From: [Maria Calderon](#)
To: [Hilary Saunders](#); [Planning](#)
Subject: Thirley Cotes Farm NYM/2019/0101/LB and NYM/2019/0100/FL
Date: 03 April 2019 18:49:06
Attachments: [image001.jpg](#)
[image002.jpg](#)

Convert/extend redundant building to form 3 holiday cottages with parking, amenity spaces & landscaping (revised scheme to NYM/2018/0247/FL) AND Listed Building consent for internal & external alterations to redundant buildings to enable use as 3 holiday cottages (revised scheme to NYM/2018/0499/LB) both at Thirley Cotes Farm, Harwood Dale.

**THIRLEY COTES FARM, WAITE LANE, HARWOOD DALE, SCARBOROUGH,
NORTH YORKSHIRE YO13 0DR
Application No. NYM/2019/0101/LB**

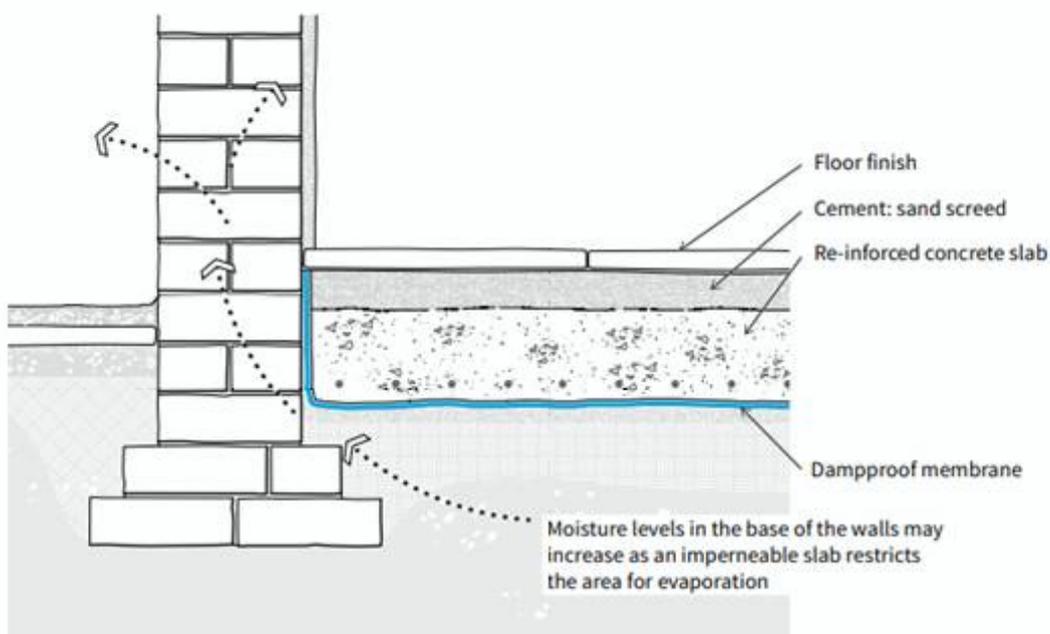
Regarding the concrete floor - the following is taken from the current Historic England guidance which is freely available at <https://historicengland.org.uk/images-books/publications/eehb-insulating-solid-ground-floors/heag087-solid-floors/>

Significant historic fabric is often lost or damaged when this type of solid floor is introduced in traditional buildings. The relaying of a floor on a damp-proof membrane restricts the amount of moisture which can evaporate through the floor. The ground moisture is often displaced to the

base of the walls where it can cause rising damp instead.”

As such in order to prevent any rising damp problems within the structure either a limecrete floor should be used or air airgap so that moisture is less concentrated though the walls. Although I admit this may still cause some damp issues, I was trying to find a solution that might suit us all. I accept that in the past this practice has been utilised, but it was recognised some time ago to cause problems and has not or should not have been a standard detail in traditional buildings for some time. A u-value of 0.2 could be met with 10mm wood fibre board and lime concrete floor which is well within the regulation for refurbishment. However, listed buildings are exempt from certain building regulations.
